Subject: Supplemental Information for Permit Modification Application to Section 404 and Section 401 permits and Neuse Buffer Certificate for the Northern Wake Expressway (I-540) from US 1 to US 64 in Wake County, Division 5. State Project No. 8.2401701, Federal Aid Project No. F-123-1(1), **TIP No. R-2000 AA, AB, AC**; State Project No. 8.U401711, WBS Element No. 34365.1.1. NCDENR-DWQ Water Quality Certification Project No. 030918 and USACE Action ID 200021863 (Previous Action ID No. 199920387 and Action ID No. 199601917).

The purpose of this submittal is provide additional information to our permit modification application dated September 27, 2004 to the Section 404 permit and Section 401 Water Quality Certification and Neuse Buffer Certificate, specifically for Section AC, Site 1. This information is for the change in design for the additional linear footage of rip rap needed to stabilize the stream bank.

Permit Drawing 4 of 9/Plan Sheets 4/Site 1

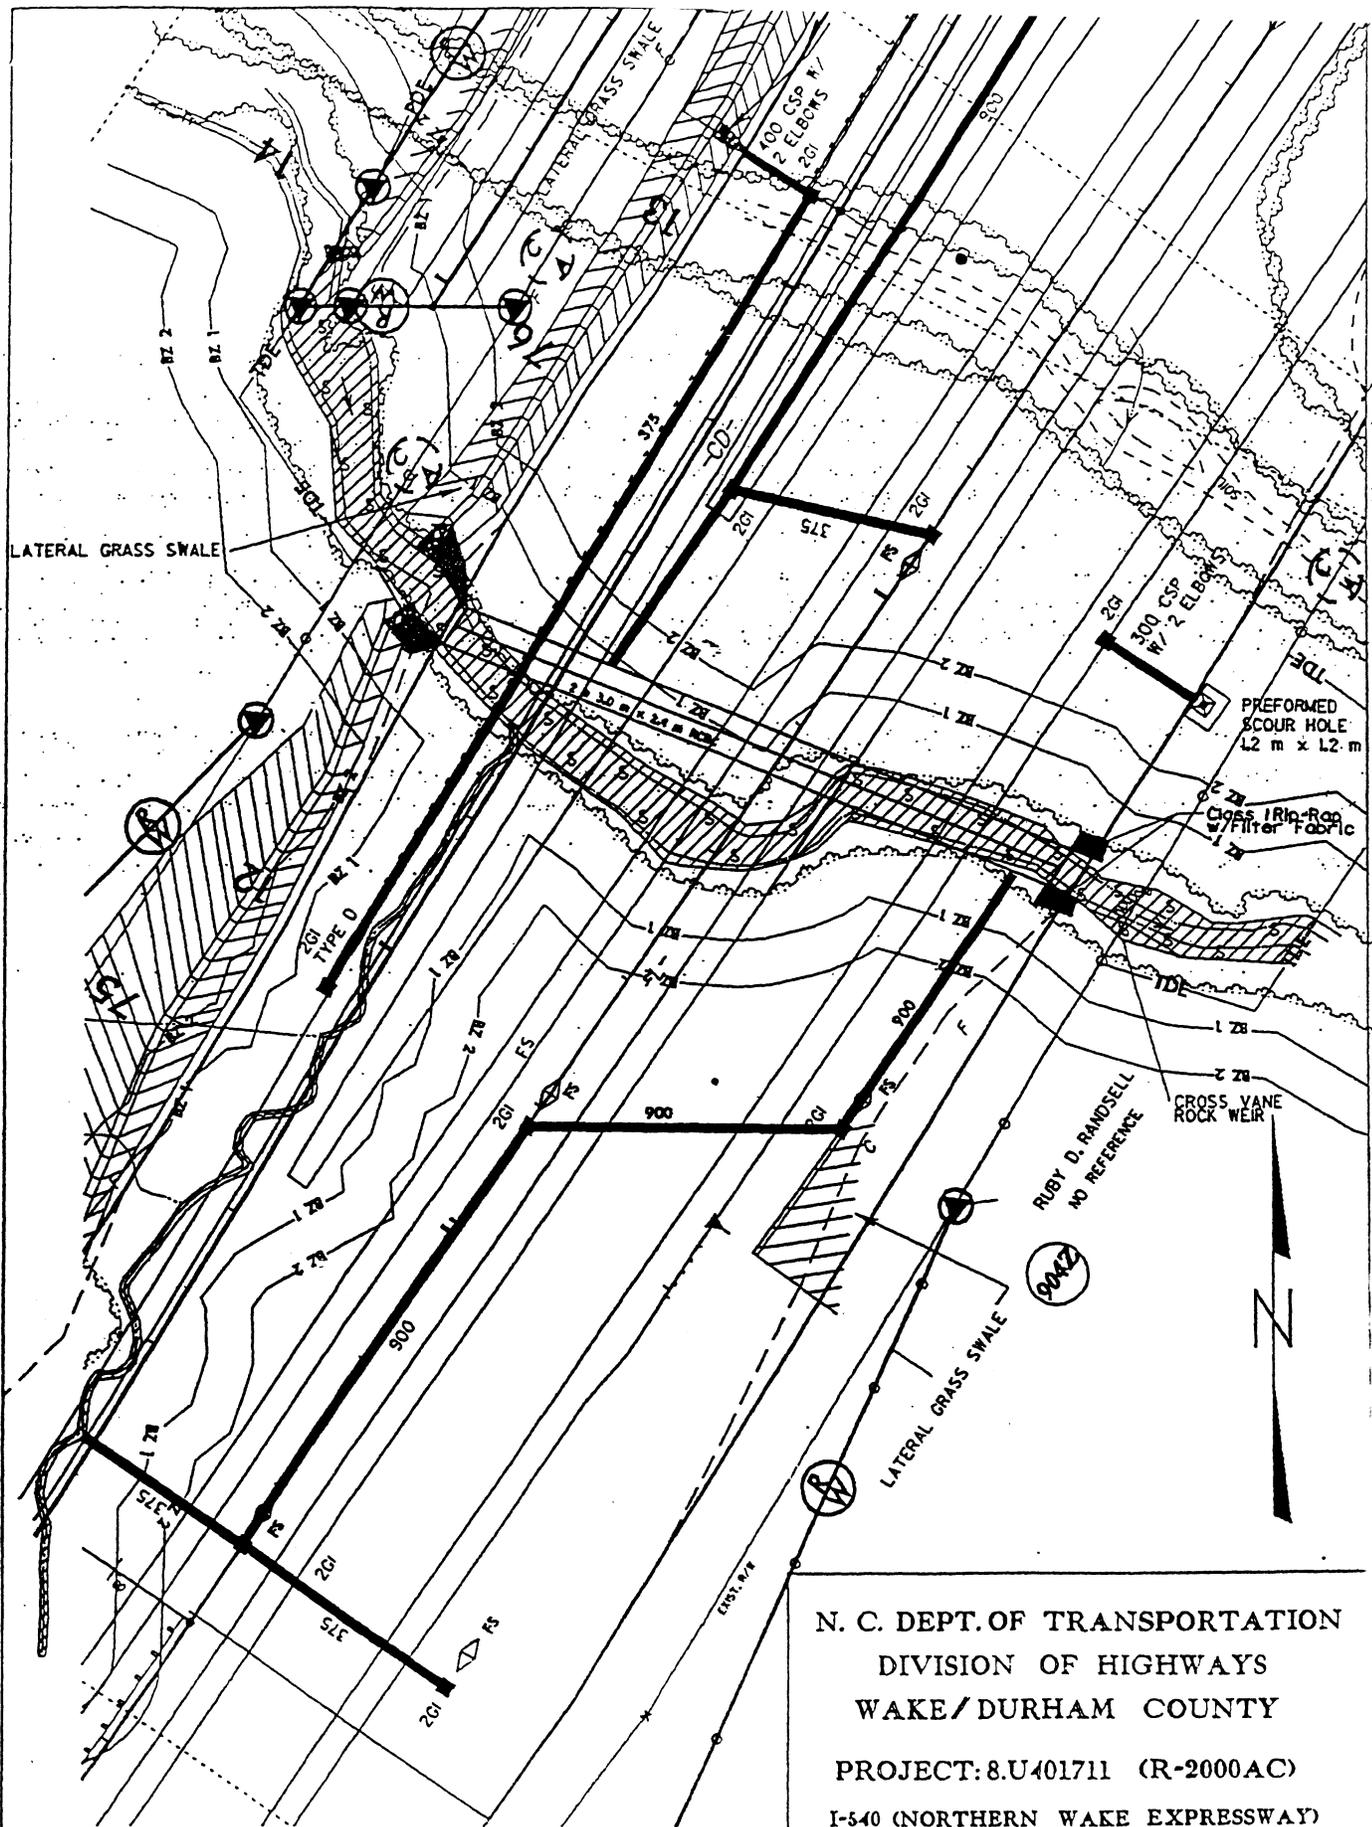
The permit drawing and summary sheet indicates that a total of 577 linear feet of stream loss has been permitted at this site associated with construction of a culvert and lateral ditches. The culvert conveys an unnamed perennial tributary to Stirrup Iron Creek in the Neuse River Basin. The permitted stream loss (as depicted in the attached permit drawing 4 of 9) can be described as extending from the Temporary Drainage Easement to Temporary Drainage Easement both above and below the culvert. The change is restricted to the placement of Class I rip rap along the west and east streambank at the inlet of the culvert and is entirely contained within the permitted footprint.

West streambank: A total of 23 linear feet (scaled) had been previously permitted for placement of rip rap along the west bank at the inlet. Field measurement of this rip rap indicated that an additional 23 linear feet of rip rap has been placed along the west bank at the inlet.

East streambank: A total of 33 linear feet (scaled) had been previously permitted for placement of rip rap along the west bank at the inlet. Field measurement of this rip rap indicated that an additional 10 linear feet of rip rap has been placed along the west bank at the inlet.

During construction of the grassed swale on the west streambank it was apparent that the Class I rip rap was needed to stabilize the existing streambank upstream of the grassed swale. The existing stream meanders as depicted on the plans. Additionally, the existing streambank configuration was essentially vertical as this area was undercutting and eroding. The additional 23 linear feet of rip rap was placed in an attempt to stabilize the existing bank in this area.

The additional 10 linear feet of rip rap placed along the east streambank was to stabilize the reconstructed streambank that was excavated for the temporary diversion channel. Stabilization fabric would not have stabilized this slope.

Please note that NCDOT has already provided mitigation for the entire length of stream loss permitted at this site (577 linear feet). The construction of the project has not exceeded the permitted footprint at the site. The change in design as described above is associated with the placement of additional rip rap along the west and east streambank at the inlet of the culvert in an effort to provide adequate streambank stabilization.

We hereby ask that the additional information provided in this letter be added to our Permit Modification Application dated September 27, 2004 to the Section 404 Permit from the USACE and Section 401 Water Quality Certification and Neuse Buffer Certification from the NCDENR-DWQ. No additional jurisdictional or buffer impacts will occur based on this new information.
